Shady Grove Sector Plan Minor Master Plan Amendment: Work Session No. 4: Mobility Analysis

Completed: 09/04/2020

SUMMARY

Figure 1 – Single Point Urban Interchange

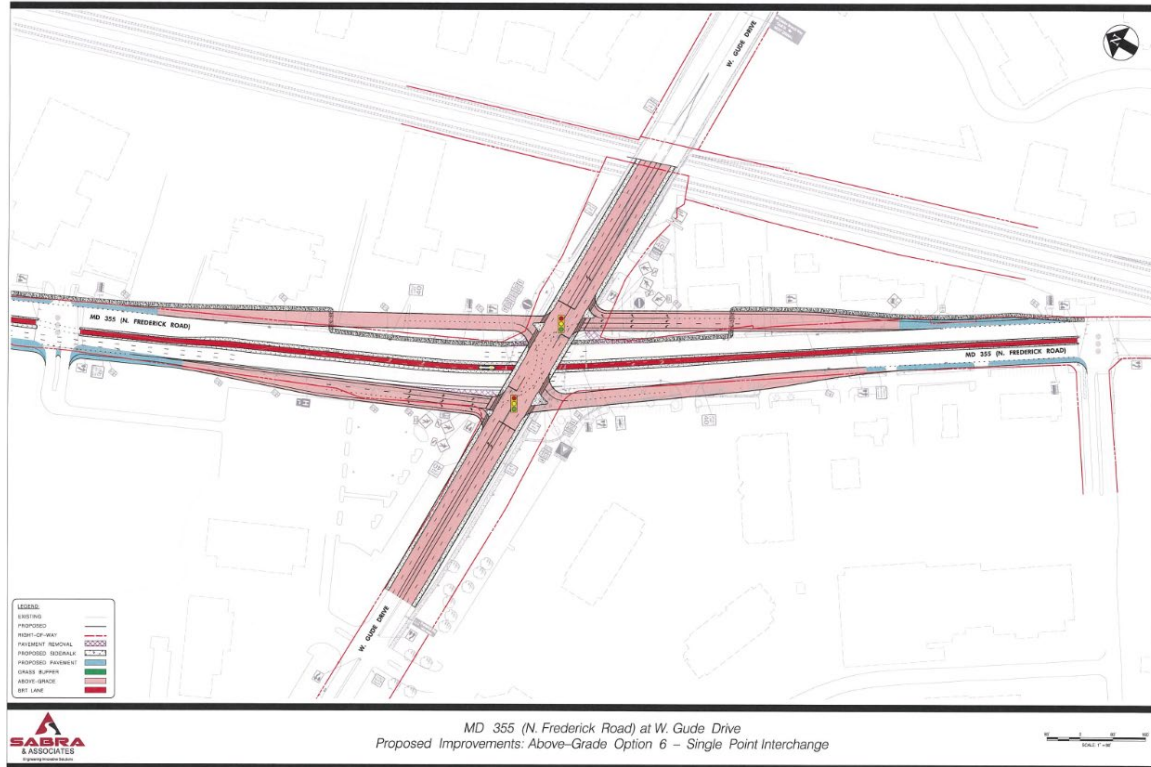
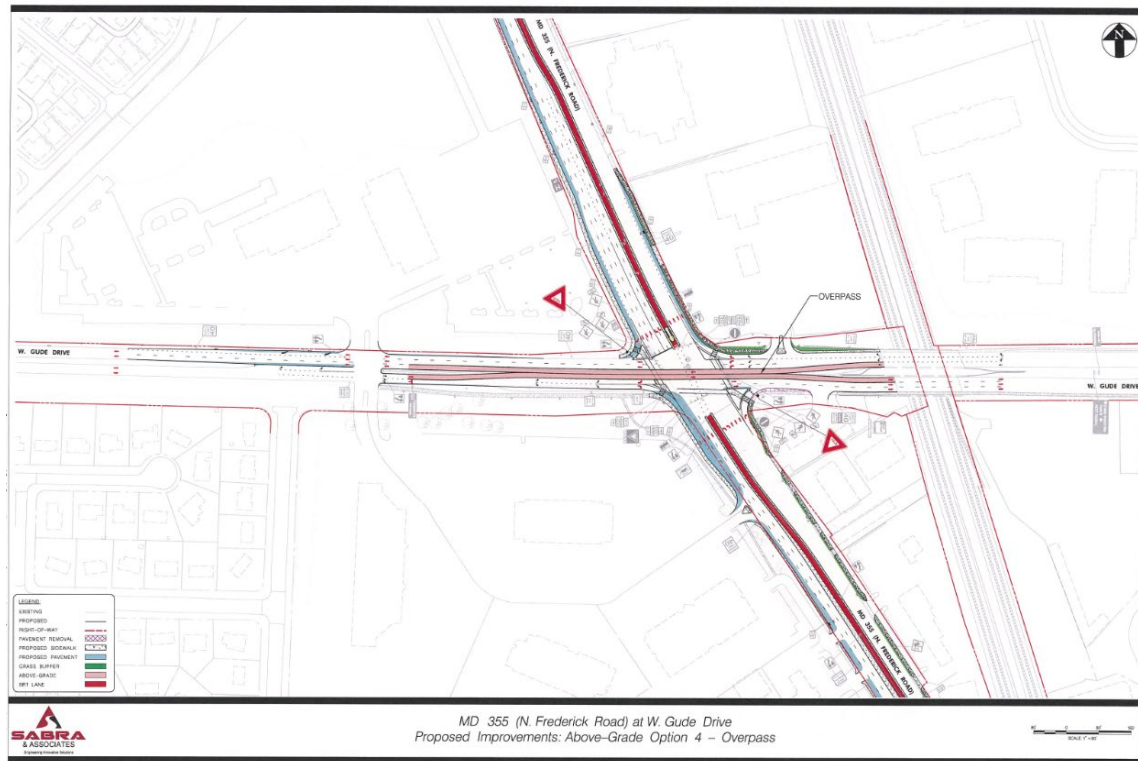
MD 355 & Gude Drive Interchange: Engineering consultant Sabra Wang & Associates worked with staff to assess the feasibility, costs, and benefits of a potential interchange at MD 355 and Gude Drive ([transportation appendix](#) (pg. 88)). This process documented significant property, access, and environmental impacts related to the implementation of either a single-point urban interchange (SPUI, shown in Figure 1) and Gude Drive Overpass (Figure 2), the two most viable interchange options. The Gude Drive Overpass option, which is projected to have a lower cost and fewer impacts than a single-point urban interchange, was modeled using a microsimulation tool. Microsimulation suggested that physical improvement of the intersection could result in modest benefits for some movements (particularly free flow movements on Gude Drive), but degradation to others. Upstream and downstream congestion along MD 355 prevents an isolated improvement from having any significant residual travel time benefit. In other words, queuing at intersections to the north and south of MD 355 and Gude Drive negates any supposed benefit of an interchange.

Both the City of Rockville and the Montgomery County Department of Transportation have commented that the State's Managed Lanes project may result in a new I-270 access point along Gude Drive, and that because of this, further evaluation of the interchange is warranted following a better understanding of the State's plans. If such an access point were to be implemented, it stands to reason that intersection volumes would increase, and that the heaviest movements would facilitate traffic from eastbound Gude Drive onto northbound MD 355 toward the Shady Grove Metrorail Station in the morning, and southbound from MD 355 back onto westbound Gude Drive in the evening. As an interchange would facilitate traffic more quickly to MD 355 in the morning, existing upstream congestion would likely be exacerbated, further reducing the benefit of any physical improvement. Department staff are working to obtain the necessary information from the State's Draft Environmental Impact Statement (DEIS) to better understand the order of magnitude for any potential volume increase associated with the Managed Lanes, but recommend the Board reaffirm its desire to remove the planned interchange from the *Master Plan of Highways and Transitways* as it is less desirable than other transit-oriented improvements.

The Plan's consultants demonstrated that more minor geometric improvements could be made to MD 355 and Gude Drive, and that these improvements would bring the intersection's average delay below the 80 seconds/vehicle standard proposed by staff. The 80 seconds/vehicle proposal aligns with the Board's thinking related to its review of the Planning Board Draft of the *2020-2024 County Growth Policy*. The *2020-2024 County Growth Policy*, which has been transmitted to Council following the Board's approval, recommends a 100 seconds/vehicle average intersection delay threshold for intersections along planned Bus Rapid Transit Corridors, including MD 355. Planning staff anticipates the 80 seconds/vehicle threshold would be superseded by any more liberal policy approved by the County Council.

Figure 3 – Two-Lane Industrial Street Standard MC-2006.01

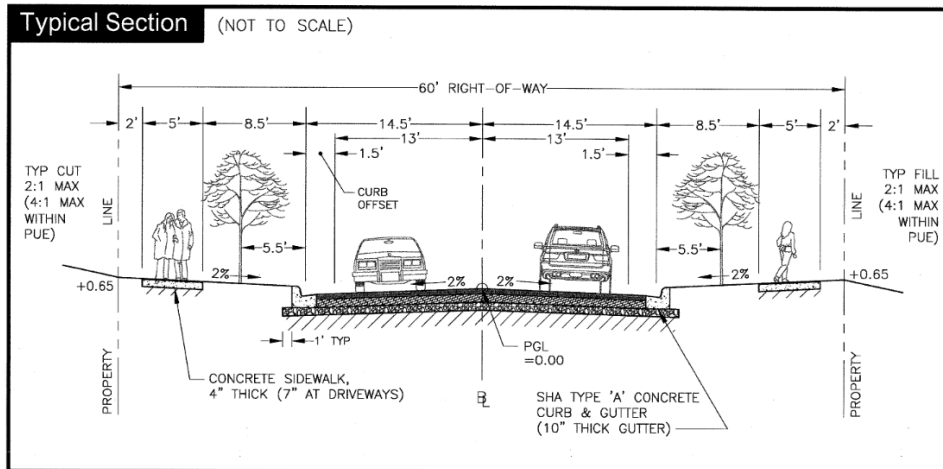
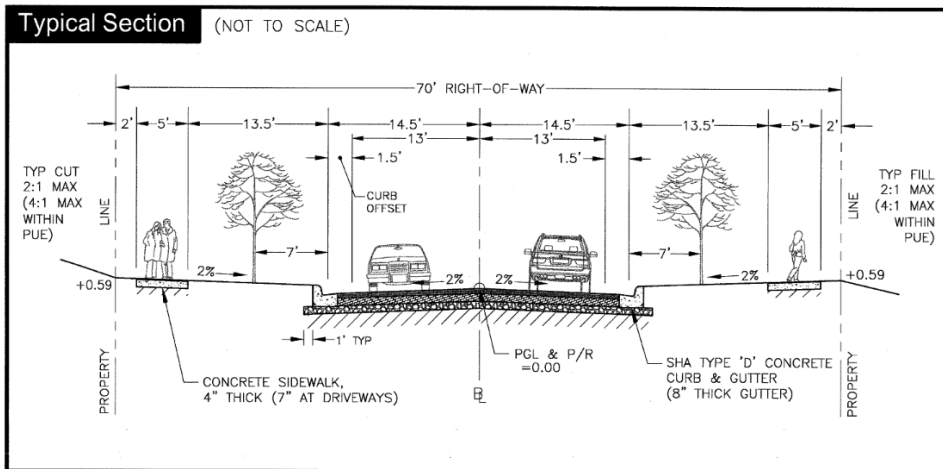
The Town contends that pedestrian safety along Oakmont Avenue has been largely ignored in the draft Plan Amendment. Staff agrees that the segment presents a very poor and unsafe pedestrian experience for users. The segment within the Plan area includes a significant number of sidewalk gaps. In some locations where sidewalks are present, they abut the roadway and lack separation from traffic. In locations where sidewalks abruptly terminate, crossings are not marked. Conditions are far from ideal.

Oakmont Avenue is currently classified as an 80-foot arterial by the *Master Plan of Highways and Transitways*. Today, the right-of-way width for the segment falling within the Plan area ranges between 25 feet and 80 feet. Generally, narrower sections prevail. The Plan did not recommend rezoning as the existing industrial uses are operating successfully. As there is no incentive to redevelop, it is unlikely that the recommended right-of-way width could be achieved in the life of the plan without property takings. A continuous sidewalk on one side of the street cannot be achieved today without property taking and utility line relocations, which would be an expensive capital project. Existing lane widths are approximately 13 feet. While two feet from each lane could be repurposed per the County's draft *Complete Streets Design Guidelines*, consistent with the Industrial Road typology, existing storm drain and swale channel infrastructure would need to be relocated and reconstructed. These constraints led staff to remove the 2018 Bicycle Master Plan bicycle facility recommendation from the roadway as it did not seem realistically achievable. A parallel connection to the Town of Washington Grove could provide an achievable alternative.

Staff also recommended the road be reclassified from an 80-foot arterial to a 60-foot industrial roadway to better align with existing conditions given the lack of prospect for redevelopment. Despite this change, staff notes that the 70-foot standard for a two-lane minor arterial (there is no existing two-lane 80-foot arterial standard) and the 60-foot industrial roadway standard are largely consistent. The 70-foot standard increases the adequate 8.5-foot separation between the sidewalk and the roadway to be 13.5 feet (see Figures 3 and 4 below). Other than buffering, the widths for each element of the two different standards are the same, and both include sidewalk facilities.

Unfortunately, without a mechanism to obtain right-of-way or relocate existing structures and utilities, discussions regarding classification are largely academic. As such, staff recommends the Board consider the addition of the following recommendation: *Encourage coordination between existing property owners, the County, and the Town of Washington Grove to improve pedestrian safety along Oakmont Avenue, including the provision of a continuous sidewalk on at least one side of the roadway.*
